Application No: DA2020/0060

Property Address: 3 Birdwood Avenue COLLAROY
Lot 2 DP 9667

Submission to Development Application (2020/0060) for No.3 Birdwood Avenue, Collaroy

No.3 unit block development – comprising 4 x 2 bedroom & 1 x 1 bedroom units including Airbnb accommodation.

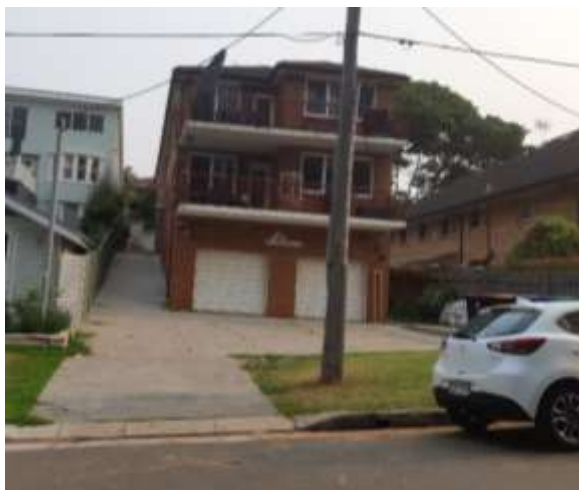
Note the fully concreted front setback and very narrow (impractical) side 'driveway' on the eastern (LH) side. This becomes even narrower where the retaining wall is located to the rear.

The current Council crossing is offset to the left of the existing double garages and if moved to the right hand side of the power pole it could better align with the double garages to provide more direct access and much improved safety.

Daily parking on No.3 is always parallel to the front of the building on the fully concreted front setback area (as well as at times on nature strip) and never within garages – the garages are used for storage only.

With this permanent adhoc parking arrangement vehicles exiting from No.3, including those associated with the Airbnb business at No.3, reverse toward our property (No.5) as well as need to negotiate a 90^o bend transition – this is a safety risk. Larger 4 wheel drive vehicles also park here. If this access and parking arrangement is to remain there needs to be a vehicle safety barrier for the protection of No.5.

An automated gate where the current driveway is located would place it in close proximity to our front building which could cause adverse noise and amenity concerns.
